Presentation: EPA Review of CAFE Model with “GHG” Settings  
Meeting with Office of Management and Budget/OIRA  
Dated: 4/16/2018

# EPA review of CAFE model with “GHG” settings (08-Mar ver.)

Meeting with Office of Management and Budget/OIRA

## Relationship between miles traveled and total fatalities

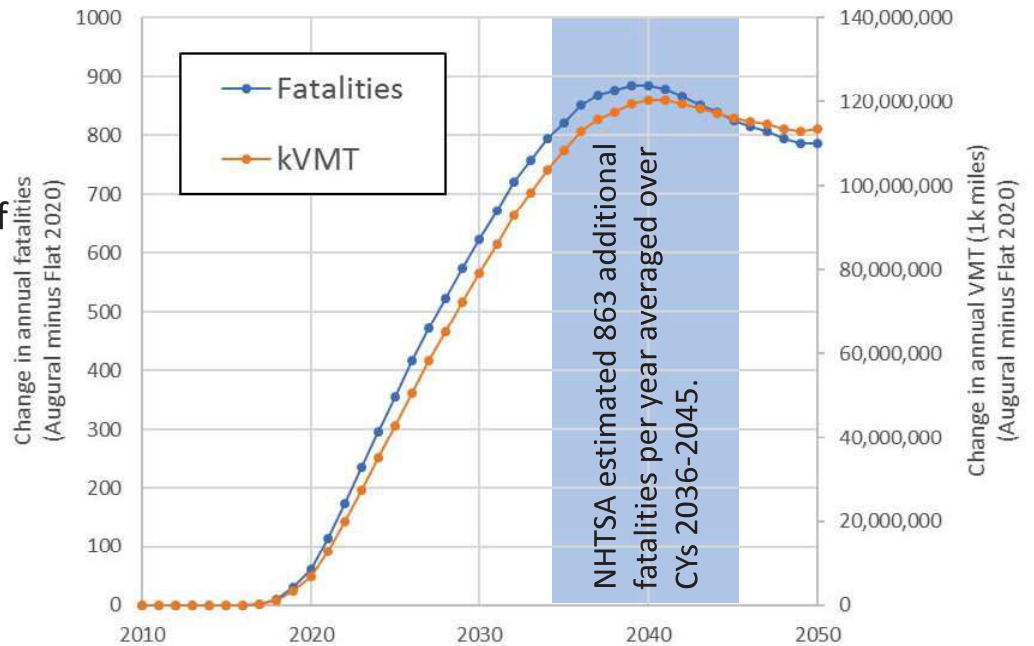
- Total fatalities are highly correlated with total VMT
- CAFE model improperly estimates the VMT impact of the Augural standards (following slides)
- The safety metric of ‘fatalities per mile’<sup>1</sup> is unaffected by anomalies in VMT projection, and is therefore a more reliable metric of safety for this review

## Effects of delayed scrappage and mass reduction (excluding rebound)

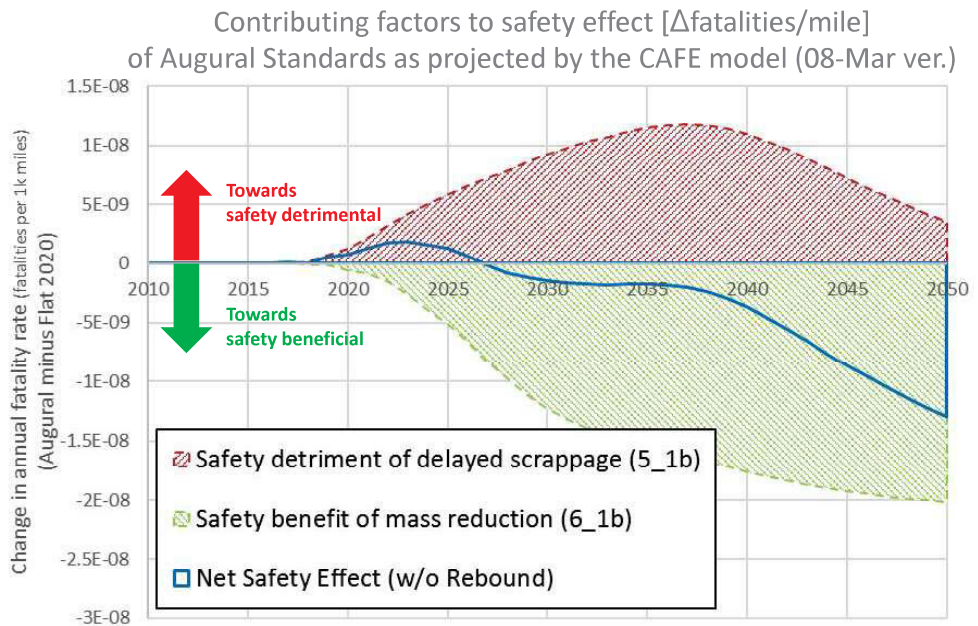
- The augural standards provide an overall safety benefit, relative to flat standards
- Mass reduction provides a safety benefit due to the greater amount of weight removed from larger vehicles (relative to smaller vehicles) and the resulting improvement in crash compatibility
- Any detriment due to delayed scrappage is more than offset by the benefit of mass reduction
- The benefit of mass reduction extends perpetually into the future, while the detriment of delayed scrappage becomes smaller over time

## Effects of delayed scrappage and mass reduction (including rebound)

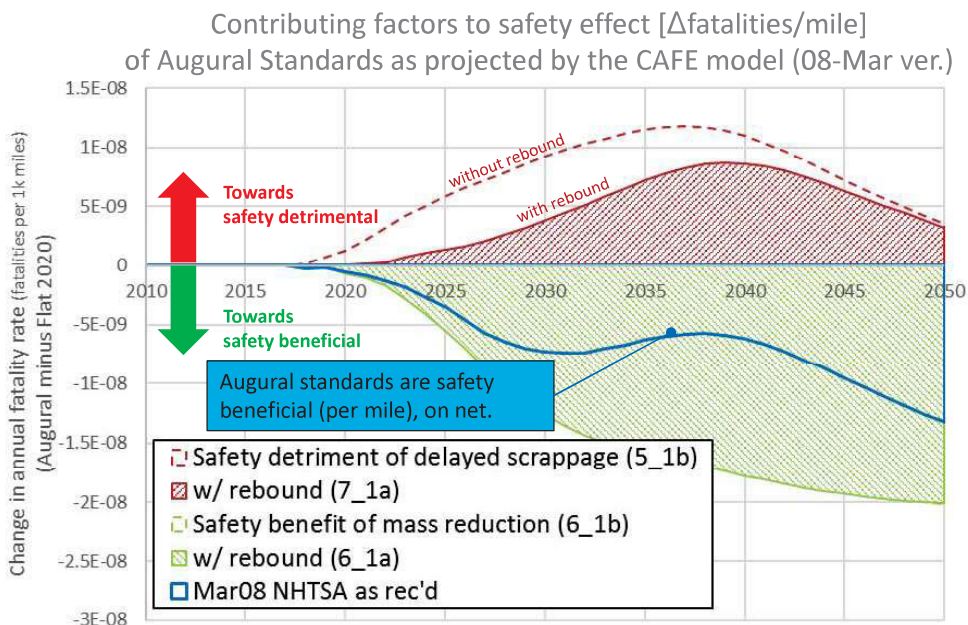
- The use of a 20% rebound value in the CAFE model reduces the safety detriment of delayed scrappage
- As in the case of excluding rebound, the augural standards provide an overall safety benefit, relative to flat standards when rebound is included

Significant increase in the total fleet size due delayed scrappage in CAFE model (08-Mar ver., Augural Standards)

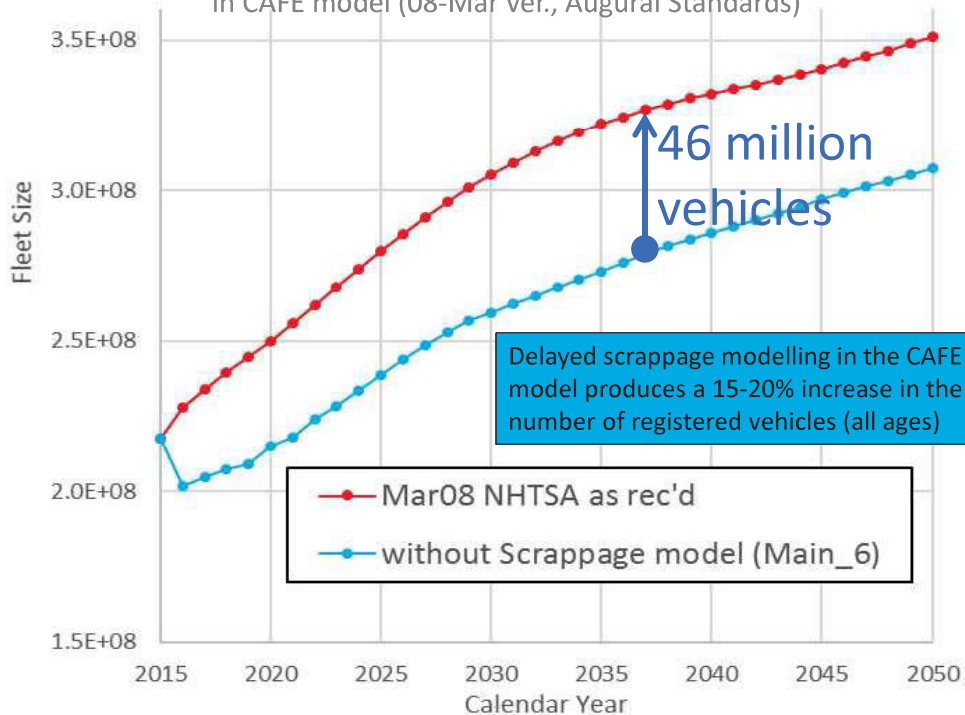
**CAFE model implementation:** The use of the scrappage model produces a 15-20% increase in the total fleet size. The 2016 fleet increases by 26 million vehicles, and the 2030 fleet increases by 46 million

**Real-world :** The total number of registered vehicles would not change significantly as a result of consumer decisions to retain used vehicles longer instead of purchasing new vehicles.

Significant increase in the total VMT due delayed scrappage in CAFE model (08-Mar ver., Augural Standards)

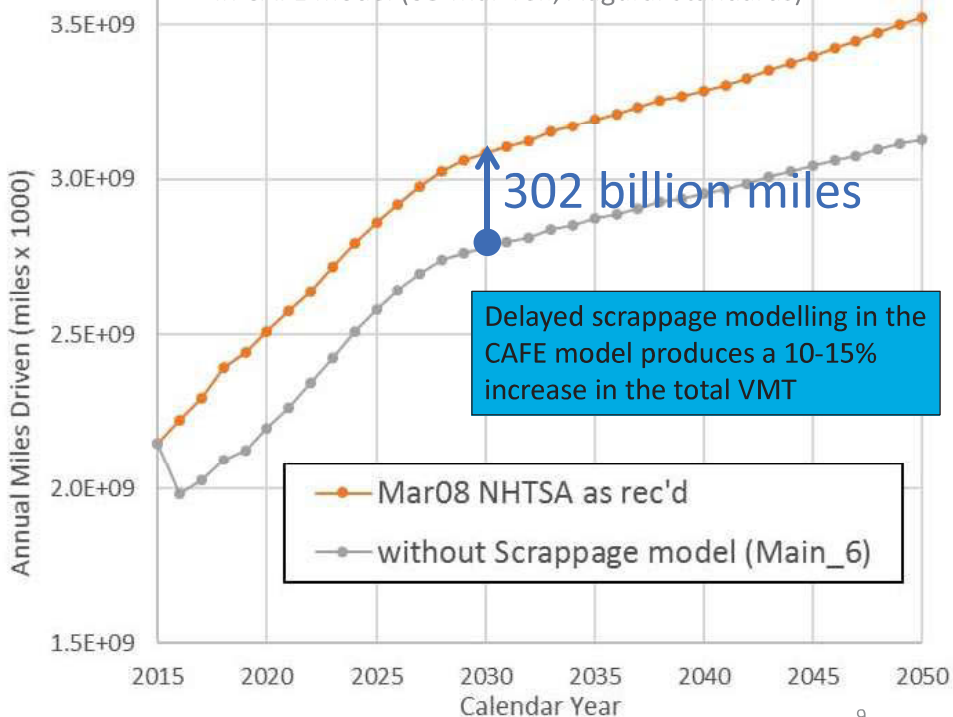
**CAFE model implementation:** The use of the scrappage model produces a 10-15% increase in total VMT.

The 2016 VMT increases by 239 billion miles, and the 2030 VMT increases by 302 billion miles

**Implication of this Error:** The unexplained VMT disconnect is clearly wrong, and is driving incorrect fatality estimates<sup>1</sup>.

**Real-world:** The total number of vehicle miles travelled (VMT) would not change significantly as a result of consumer decisions to retain used vehicles longer instead of purchasing new vehicles.

## Manufacturer year-by-year compliance strategy projects

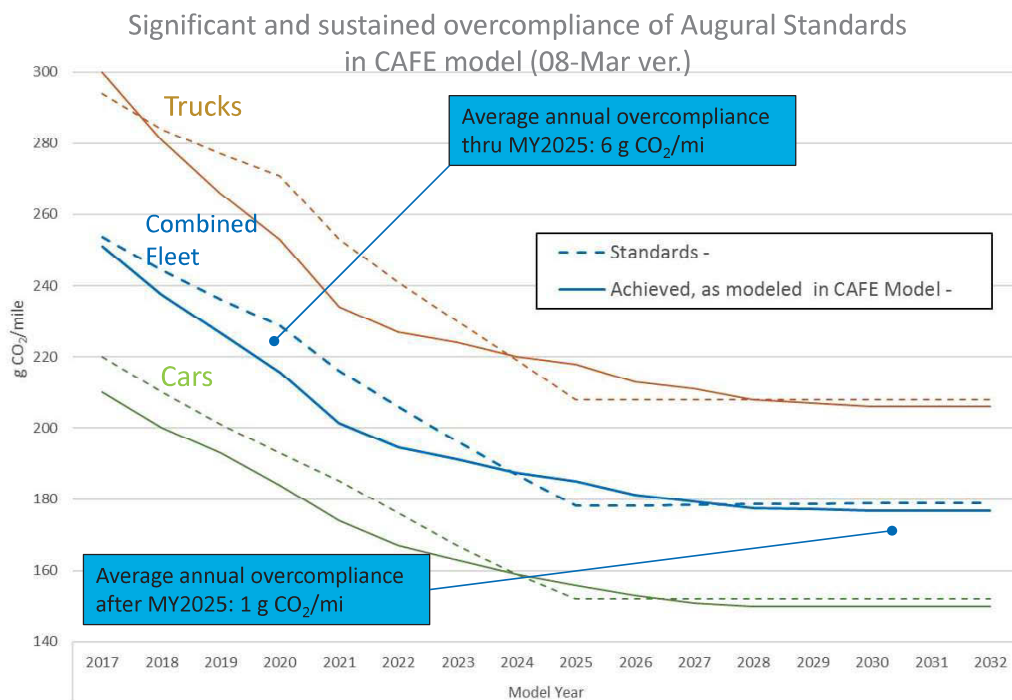
**CAFE model implementation**: Technology in excess of what is necessary for compliance is applied in nearly every year, particularly prior to MY2024 when lead time is more limited. This sustained and significant overcompliance projected by the CAFE model implies that the industry will not make use of the large quantity of banked credits, or year-to-year credit transfer provisions.

**Implication of this overcompliance**: Significant overestimation in industry costs. CAFE model is not properly accounting for banked credits in GHG program, which firms clearly do today.

**Real-world**: Manufacturers will consider future vehicle model plans and compliance strategy when introducing technology, transferring credits from year-to-year as needed and avoiding significant over-compliance, on average.

Within-manufacturer transfer of earned credits, Augural Standards in CAFE model (08-Mar ver.)

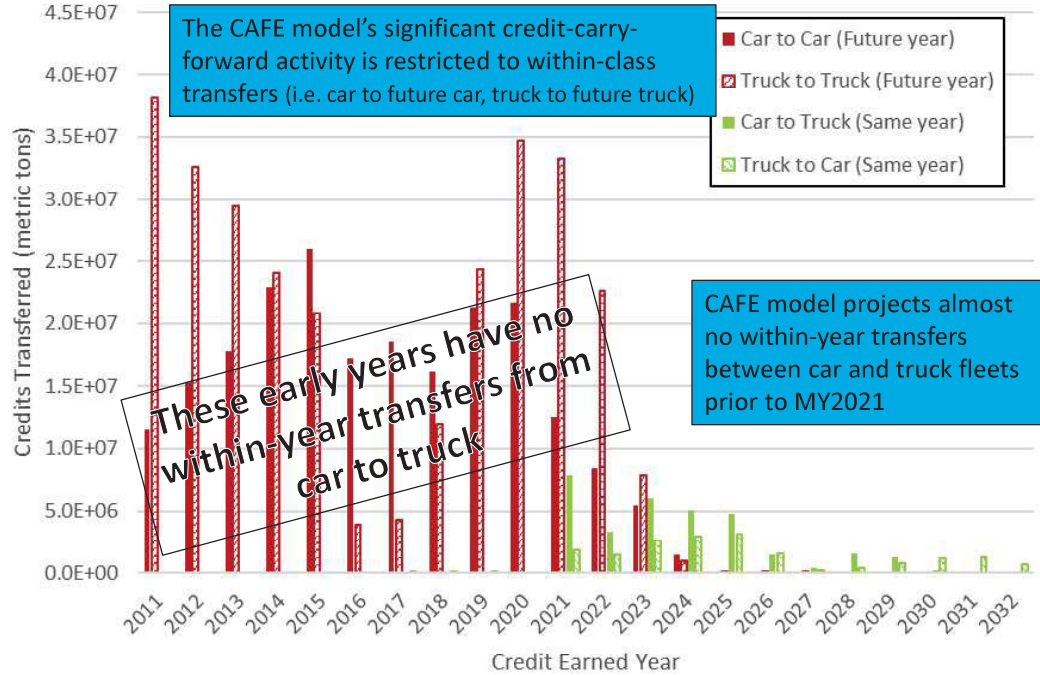
**CAFE model implementation:** Manufacturers are projected to strongly prioritize the carry-forward of credits into future years, relative to within-year transfers between car and truck fleets. The CAFE model projects almost no within-year transfers between car and truck fleets prior to MY2021

**Implication of unrealistic credit carry-forward:** Overestimation of GHG standards cost. CAFE model not taking advantage of car-truck credit transfer, which firms are clearly doing today

**Real-world :** Manufacturers will manage their credit banks to even out compliance status given staggered introduction of technology. It is unlikely that manufactures will consistently add excess technology in the earlier years in order to maintain a large credit bank into the future.

Strong Hybrid Technology Pathway Comparison: Turbo vs. non-Turbo:  
Augural Standards in CAFE model (08-Mar ver.)

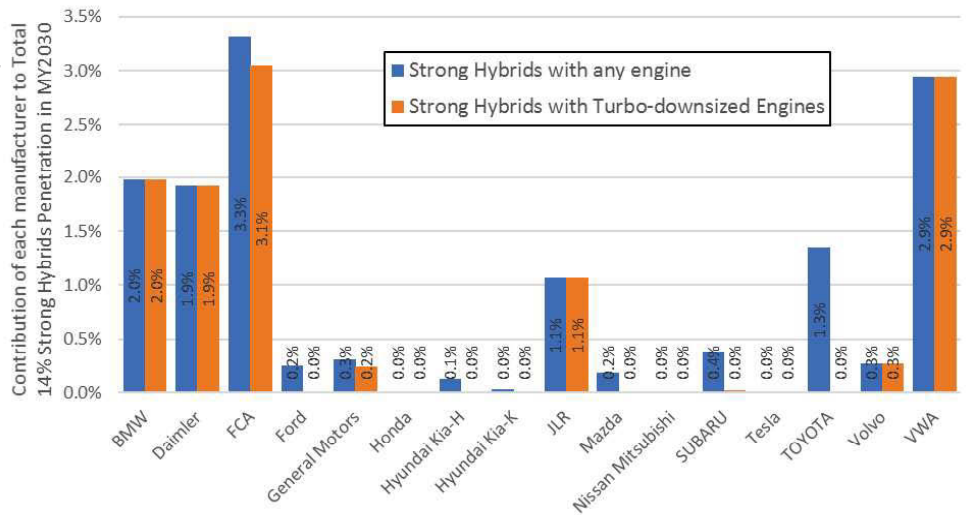
CAFE model implementation: Over 80% of the strong hybrid packages applied in the Augural case include turbo-downsized engines (11.5% of 14% fleet-wide strong-hybrid penetration)

Strong Hybrid Technology Pathway Comparison: Turbo vs. non-Turbo:  
Augural Standards in CAFE model (08-Mar ver.)

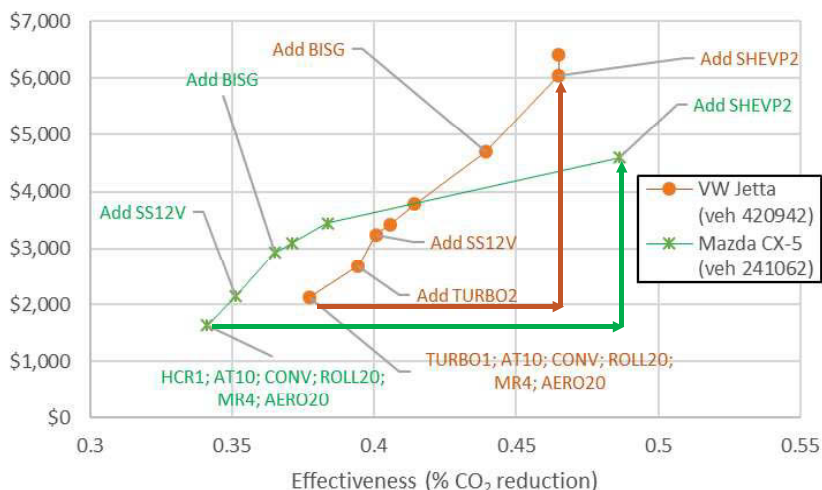
**CAFE model implementation**: Due to the CAFE model's pre-defined technology pathways, strong hybridization is applied almost exclusively to turbocharged downsized engines, resulting in strong hybrid packages that are significantly higher costs and less effective than the vast majority of real-world implementations.

**Implication of strict technology pathways**: Overestimation of GHG standards cost. CAFE model is forcing combinations of technologies that are highly cost-ineffective.

- Strong Hybrid applied to Turbo engine: \$3,900 and 8% CO<sub>2</sub> reduction
- Strong Hybrid applied to HCR1 Atkinson cycle engine: \$3,000 and 15% CO<sub>2</sub> reduction

**Real-world**: The effectiveness benefits of strong hybridization (P2HEV and PSHEV) is dependent on the base engine technology to which the technology is applied. In typical applications, manufacturers will pair strong hybridization with efficient, but low cost Atkinson cycle engines.

## Addition of plug-in electrification in reasonable volumes

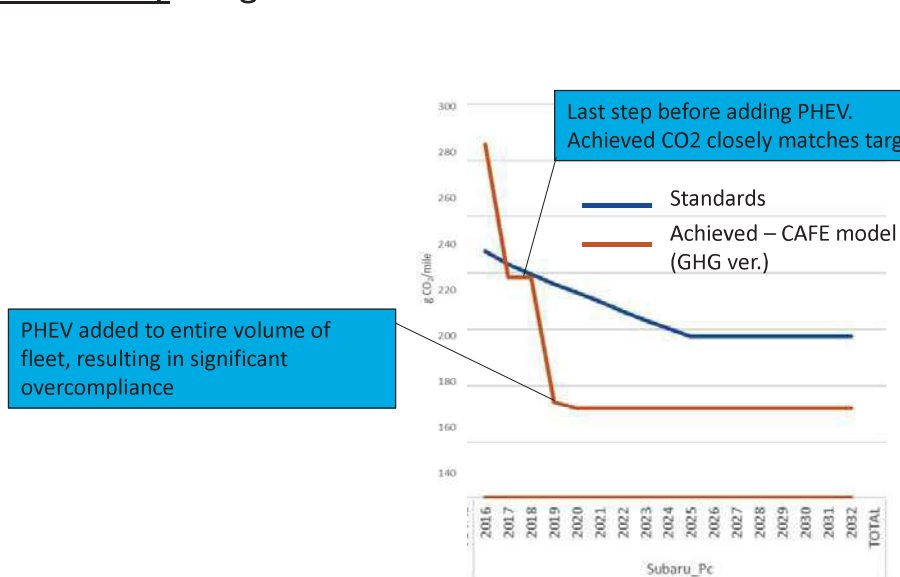
CAFE model implementation: PEV technology is applied to platforms in 'all-or-nothing' manner, resulting in an inability to track the standards closely, and producing overcompliance levels ranging from moderate to very high.

Real-world : Plug-in vehicles (PEV's) provide significant compliance benefits due to low or zero emissions and multiplier incentives. Mainstream manufacturers will likely continue adopt PEV's in a strategic fashion, without drastically exceeding the volumes needed for compliance

Average CAFE model technology costs are \$1,000-\$2,000 more costly than the most cost-effective packages.

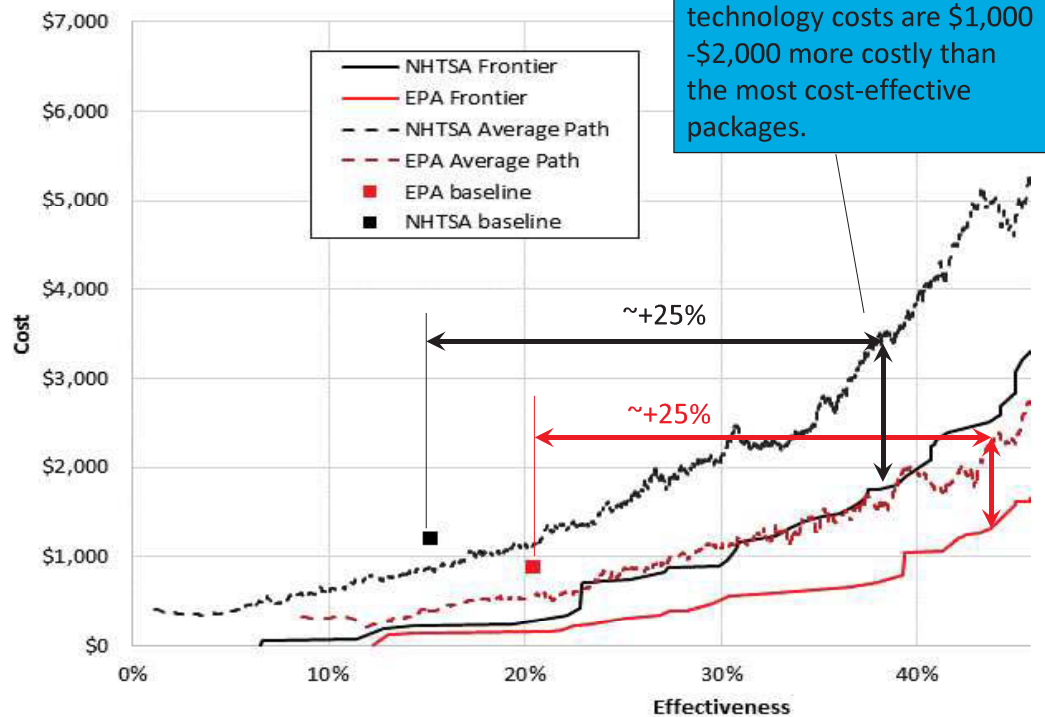
**CAFE model implementation:** Using the NHTSA inputs, as provided, manufacturers are projected to apply, on average, technology packages that are \$1,000-\$2,000 more costly than the most cost-effective packages.

**Real-world:** Manufacturers will apply technology packages that are within a reasonable cost range of the most cost-effective technologies (e.g. well within \$2,000)

## Battery Costs

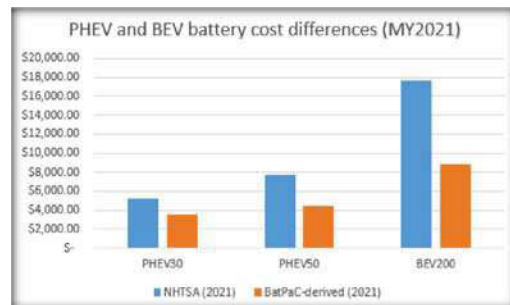
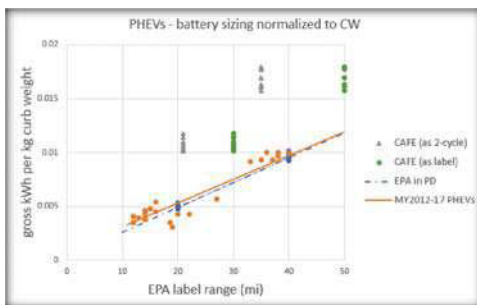
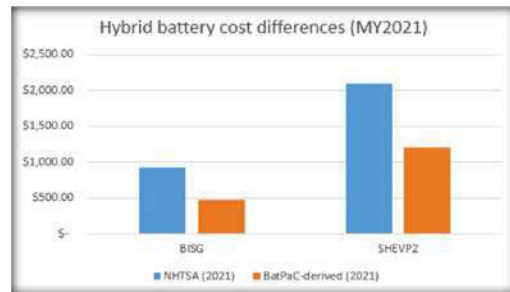
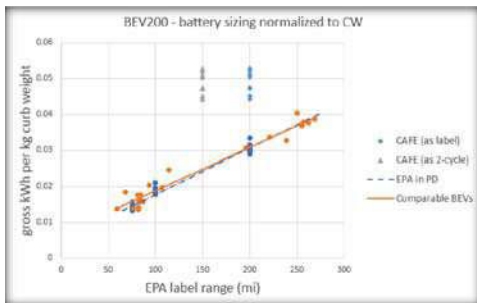
- The cost of batteries for hybrid and plug-in vehicles is in most cases significantly higher than expected based on the most recent projections derived from DOE's BatPaC model and battery sizes are substantially larger than observed in the current LD fleet.

## CAFE Model Projects Unquantified and Unmonetized Increase in Vehicle Performance

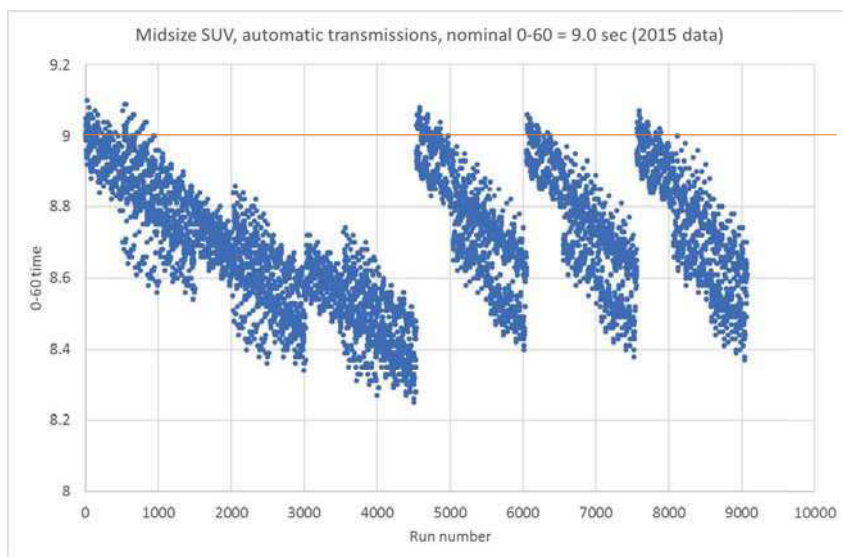
However, applying lower levels of mass reduction, advanced transmissions, or other load reduction will increase acceleration performance.

This additional benefit is not accounted for in the CAFE model.

*Target 0-60 time for this class is 9.0 seconds. Actual DOT Autonomie simulations show 0-60 accelerations much better than the target for many technology packages.*

## Summary of the representation of GHG Program elements in the CAFE model

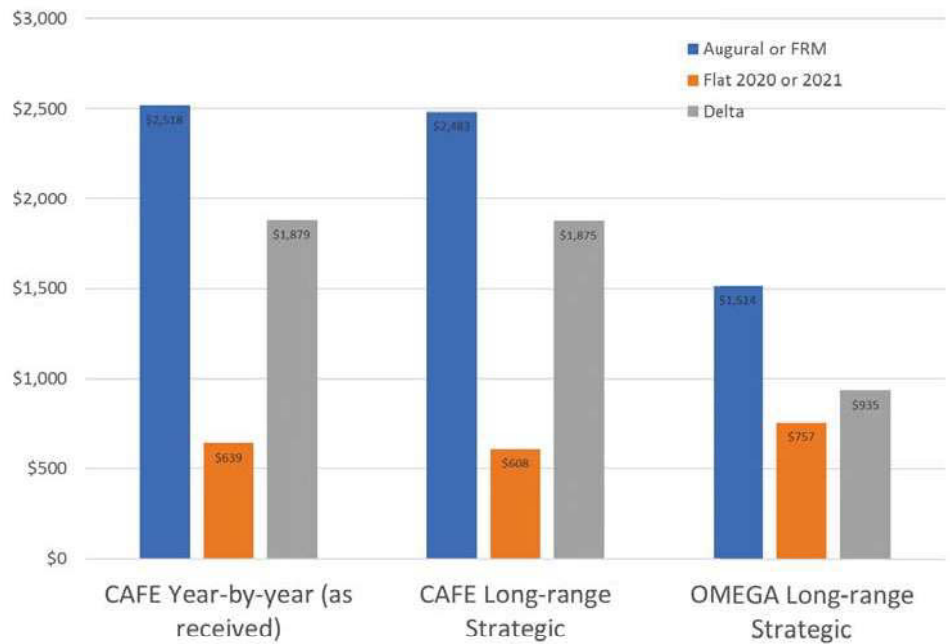
Program element	CAFE model implementation issues
BEV and PHEV Advanced Vehicle Technology Multipliers	CAFE model only adjusts the fleet average emissions to account for the multiplier values. For proper accounting of credits, the multipliers must also be incorporated into the GHG target.
Accounting for plug-in vehicle (PEV) upstream emissions	CAFE model does not have any inputs or apparent mechanism for accounting for the upstream emissions of PEVs, as required by the EPA regulations
A/C credits (efficiency and leakage)	The input files, as received from NHTSA, assume that all manufacturers earn a constant credit from AC efficiency and leakage in all years. However, the inputs for the standard footprint curves are adjusted for AC efficiency and leakage that increases over time. As a result, the standards defined in the CAFE model, as received, are less stringent than the actual standards.

Unlimited transfer is allowed within a manufacturer between car and truck fleets	CAFE model does not realistically account for car-truck credit transfers within a manufacturer (as described in earlier slide.) This likely contributes to the model's overall overcompliance, and the associated increase in costs.
Off-cycle Emission Credit caps	CAFE model inappropriately applies the credit cap (10g/mi) separately to each manufacturer's car and truck fleets. The GHG regulations specify that the cap is applied to a manufacturer's combined fleet.

Observations of Transmission Effectiveness

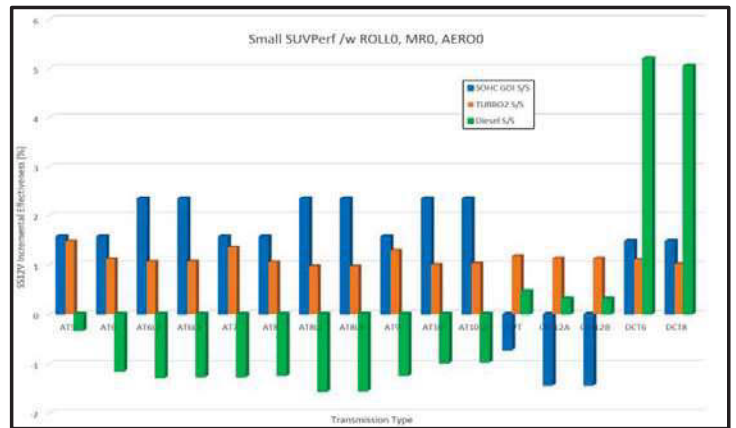
- Consistent values could indicate lack of resolution in modeling (single values being applied broadly).
- Additional technology does not follow a logical progression of improvement.
